TECHNICAL REPORT

No. 5/83

Investigations and Findings
concerning the
Sodium Tank Leakages

SSPS Technical Report No. 5/83

Figure 1 : COLD SODIUM - STORAGE VESSEL

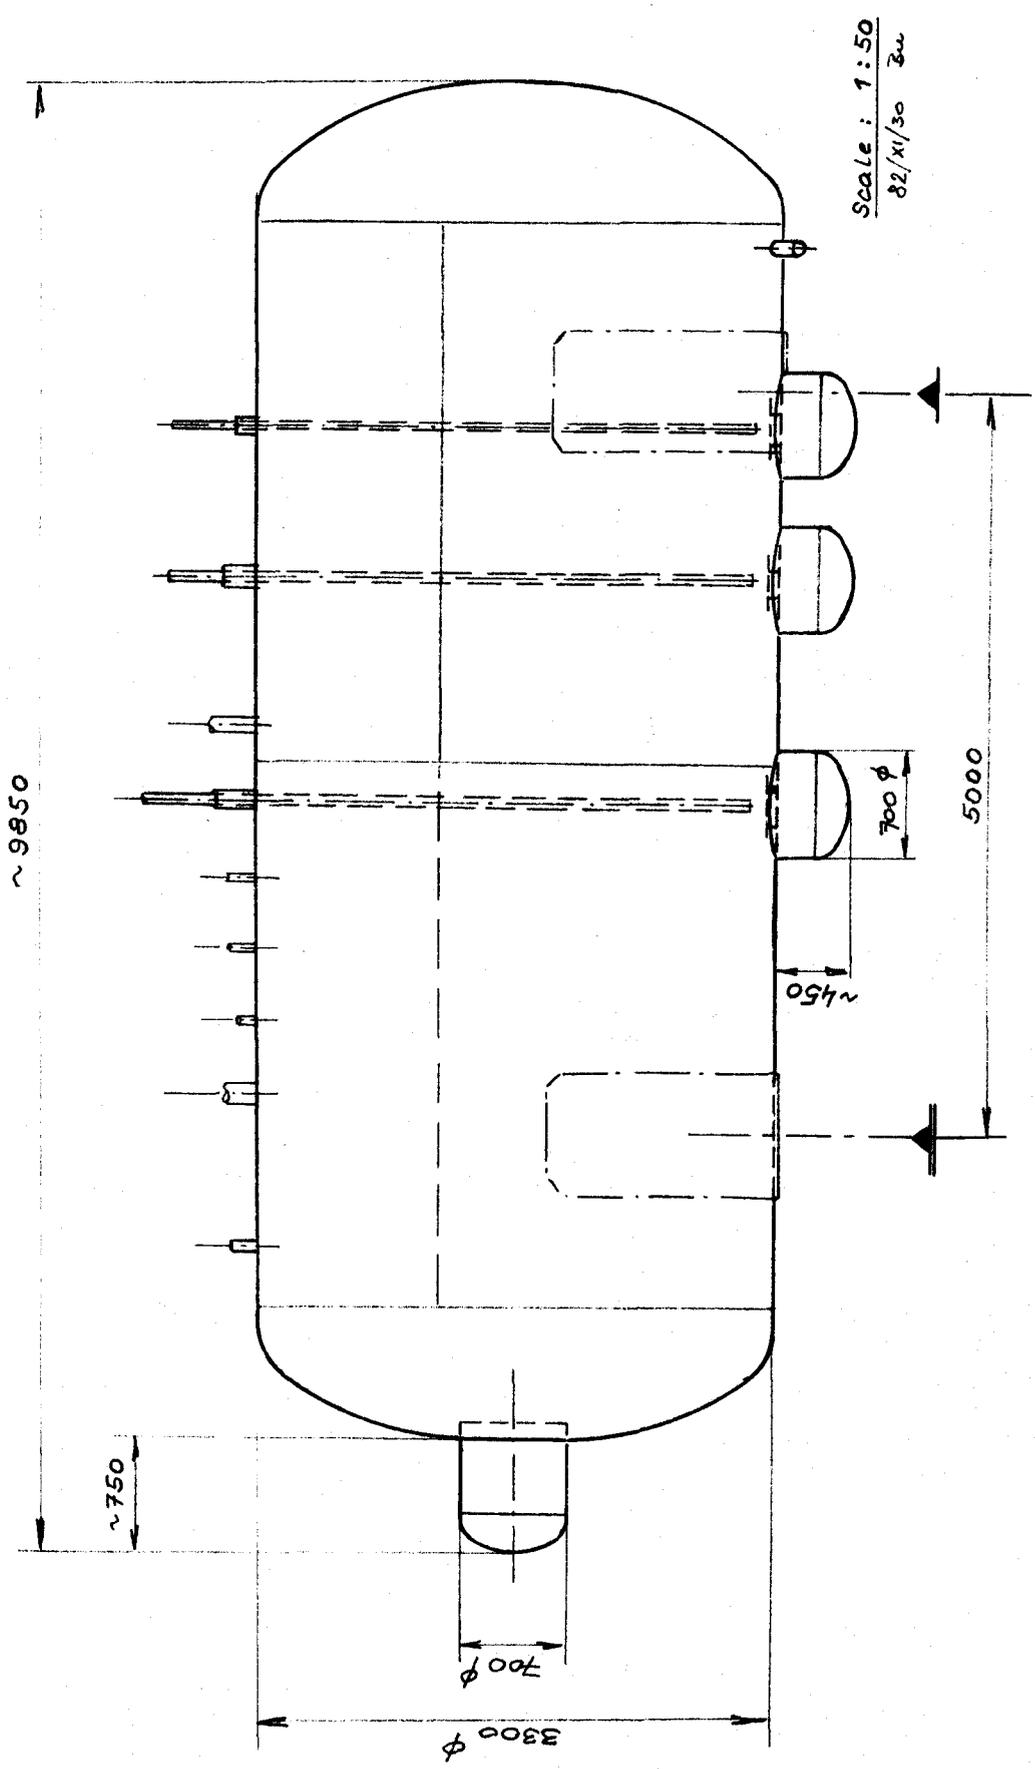
Figure 1 shows the cold sodium tank. The three "studs"* shown on the underside were fitted early in 1982 as part of the procedure to deal with sodium leaks and cracking in the bottom of the vessel.

The manhole "stud" at the end of the tank, Figure 1, is provided to allow access during installation on site. Part of the stud is fitted to the vessel during manufacture and a circumferential weld joining the two circular sections is the final weld on site that is made when the rest of the manhole stud is connected. Three leaks from cracks in this weld occurred in September 1981.

Interatom proposals for this vessel are to cut off and replace the bottom of the vessel, referred to as the manhole, and to stress-relieve the weld. VOEST have said that they could stress-relieve the whole vessel if it were necessary to do so.

Figure 2 : SHOCK PLATE IN VESSEL

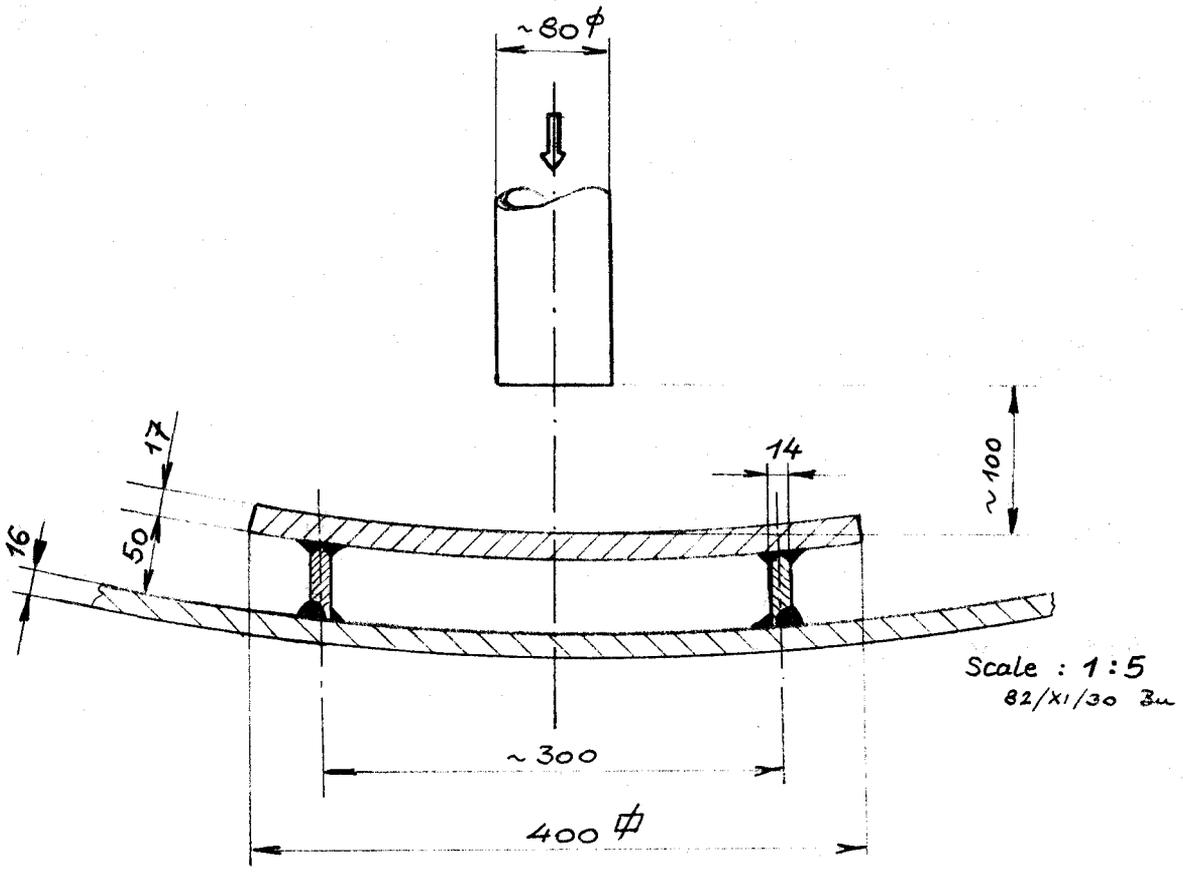
All the leakage and cracking events in the tank bottom are associated with these "shock plates" and subsequent repairs. Each of the three plates is attached to the tank bottom by two parallel metal rails that are first welded to the underside of the "shock plate" and then to the tank bottom. Figure 2.

The proposed repair to the tank bottom will remove the "shock plate" design features that have caused the series of leakage and repair problems in the past. In welding a new section into the tank bottom, the measure proposed by Interatom appear to be adequate to ensure an acceptable repair. Particular features are

Figure 4 : COLD SODIUM TANK TEMPERATURES

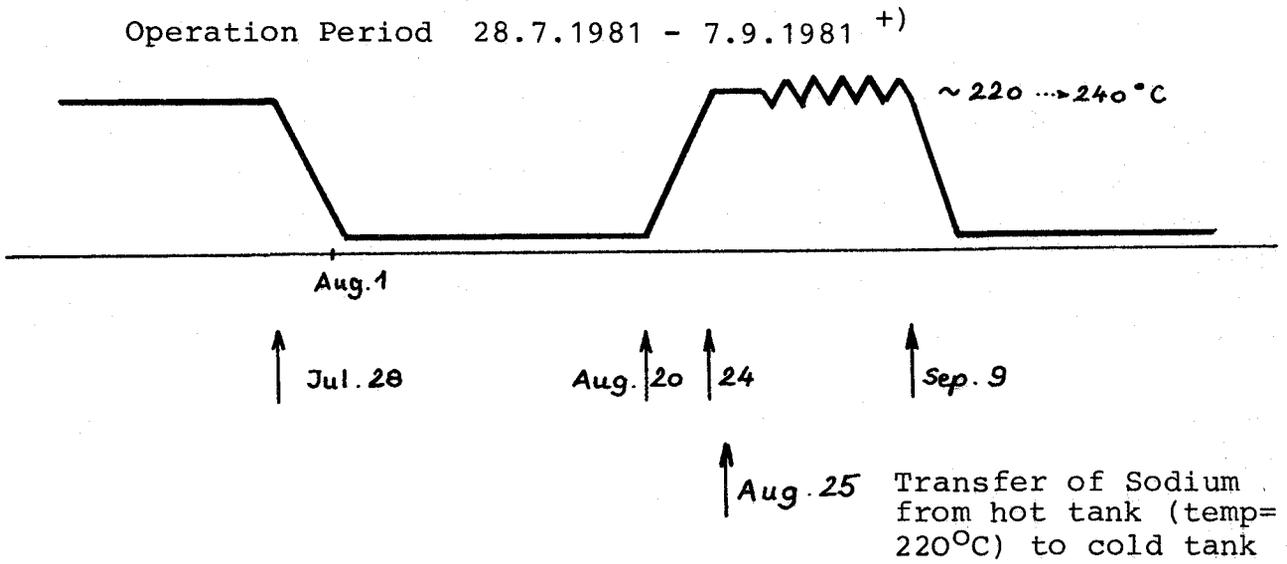
Records from these thermocouples are available for four days: 22 to 25 September. They show temperature cycles on the inlet pipe up to 210° C and at the tank bottom of up to, say, 40° C with a maximum transient on the tank bottom of 4.5° C/minute.

Figure 5 : BLEED LINE LEVELS , SPILLING PCS

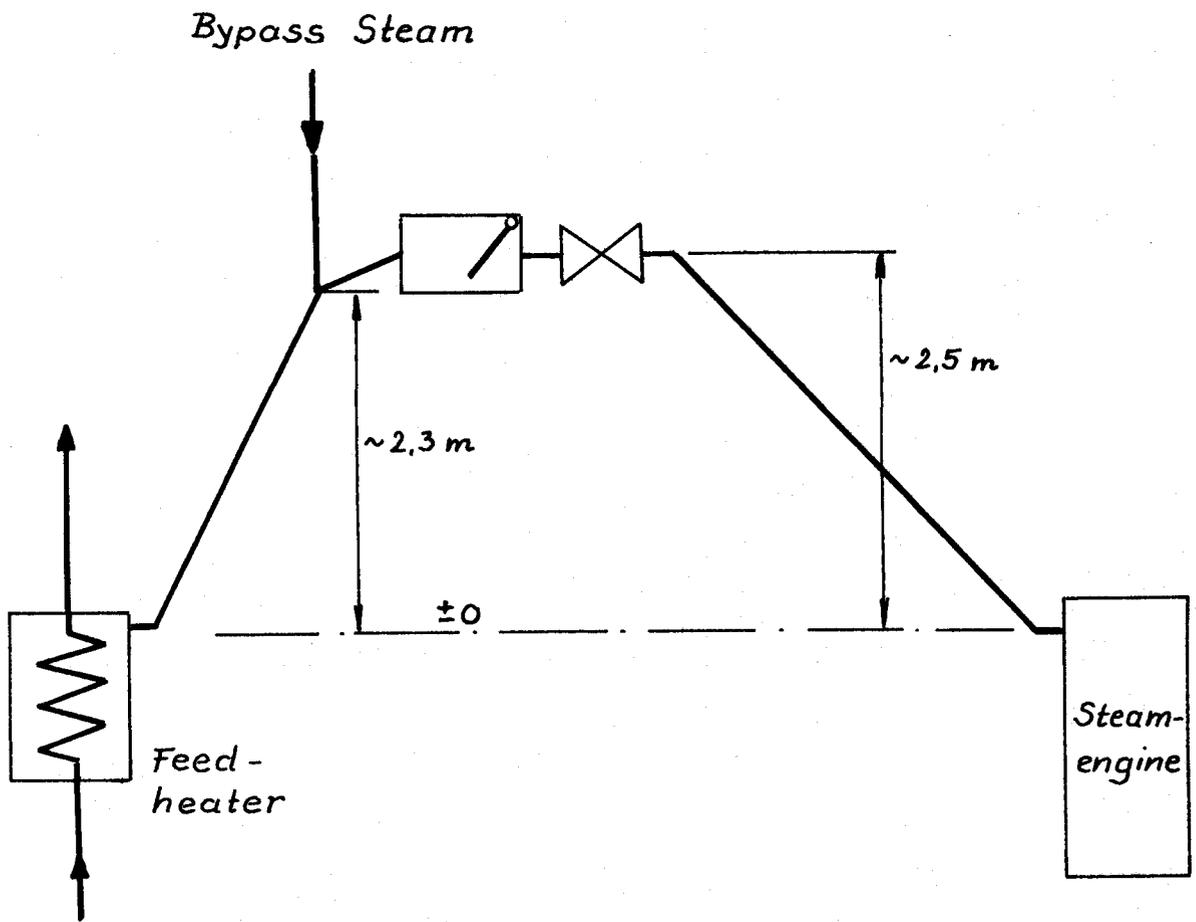
The enclosed sketch, Figure 5, shows this arrangement. The information was phoned by Mr. Pescatore in Almeria. He could not find drains on the engine side, but the insulation makes checks extremely difficult.

Plants with this arrangement can only run satisfactorily with special precautions. Very important is the consideration of the start-up by-pass into the three feed heaters. This by-pass produces full load pressures in the heaters, independently of the load on the steam engine! The cold steam engine before the start-up must be able to accept cold vapor leaking through the non-return valves. This vapor condenses in the pipe and runs into the engine, into the slide-valve of the next lower cylinder, unless it is prevented from doing so by fitting drains.

- c) Condensate from re-heater. Drains according to b) should also be fitted to the secondary side of the re-heater.

Fig. 3: Evaluation of allowable cycles at paffle plate area (----- old design) and undisturbed vessel wall (—— new design)

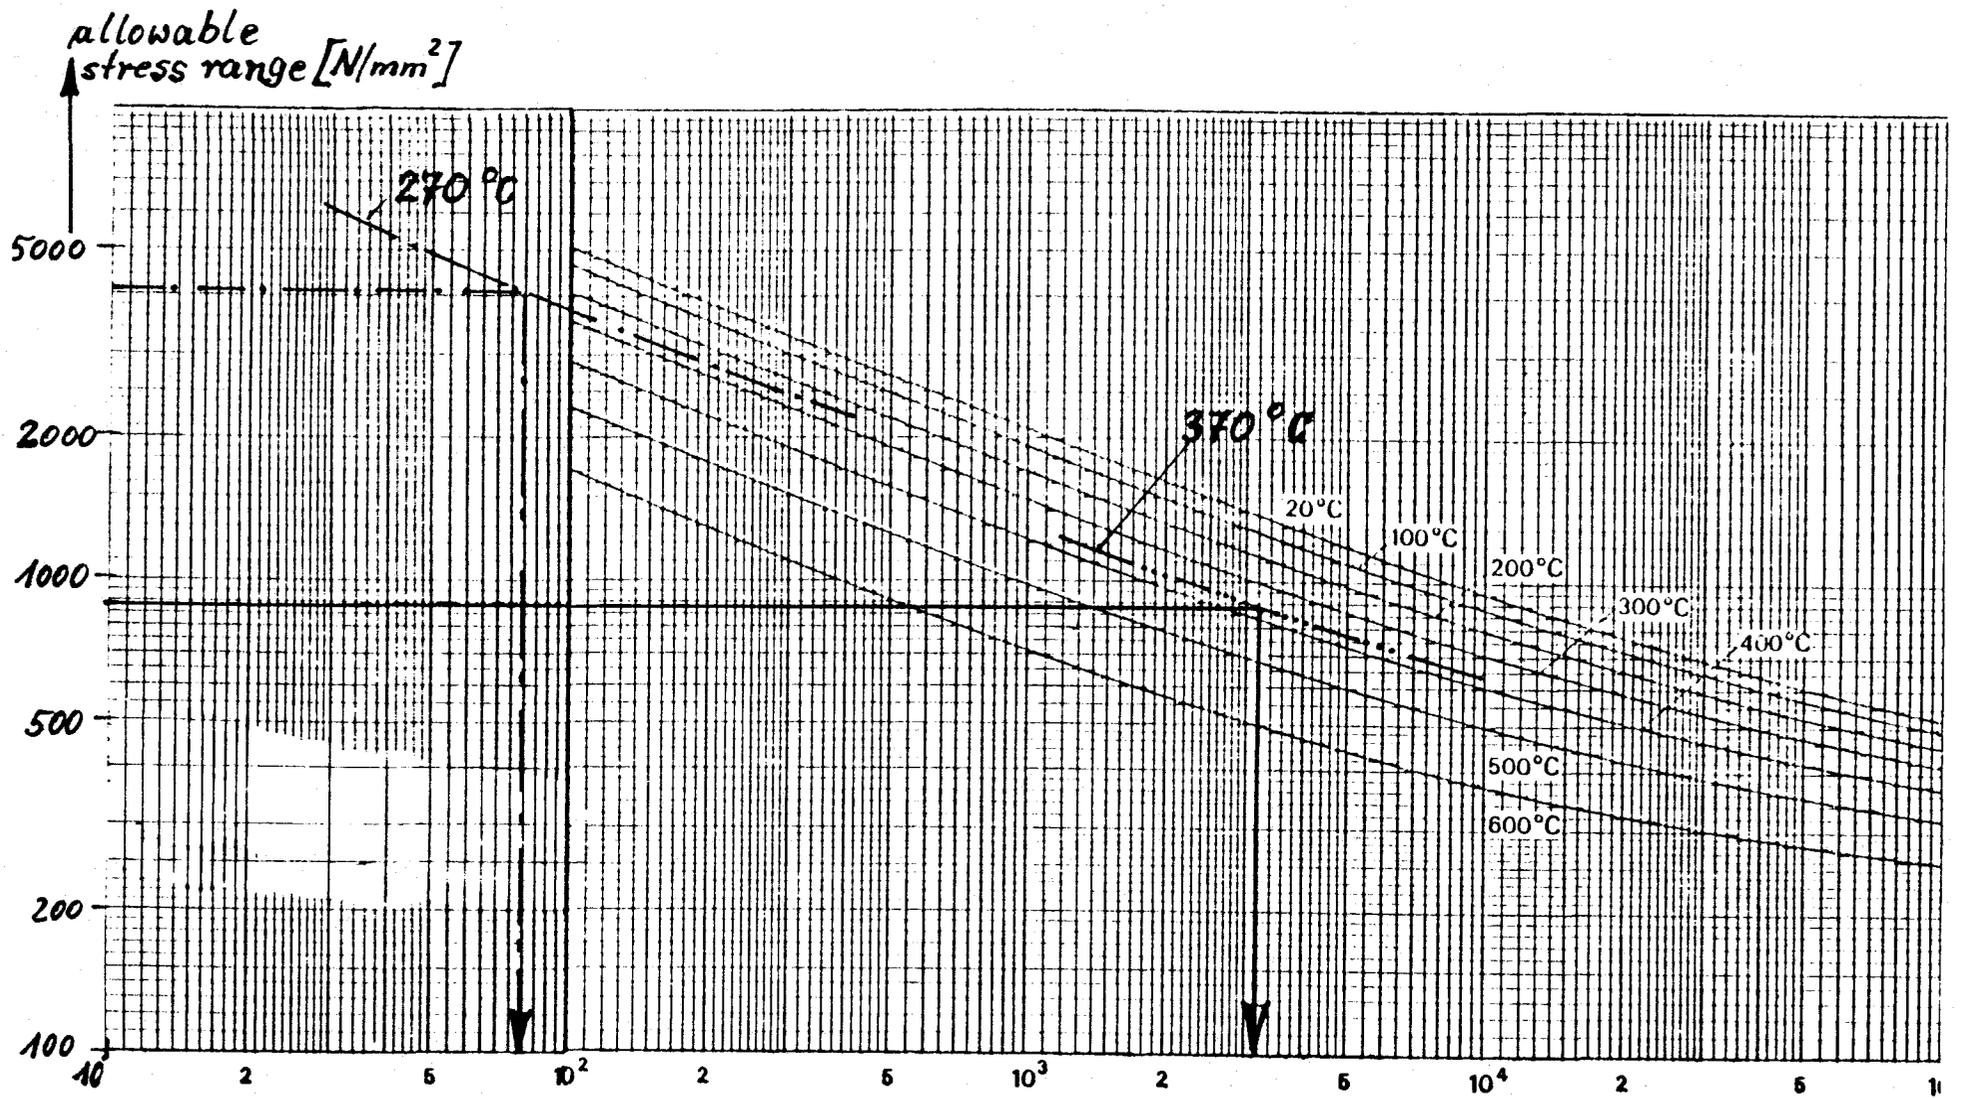
$n_{\text{allowable}} \approx 80$ (see figure 3 corresponding to figure 8 of TRD 301)
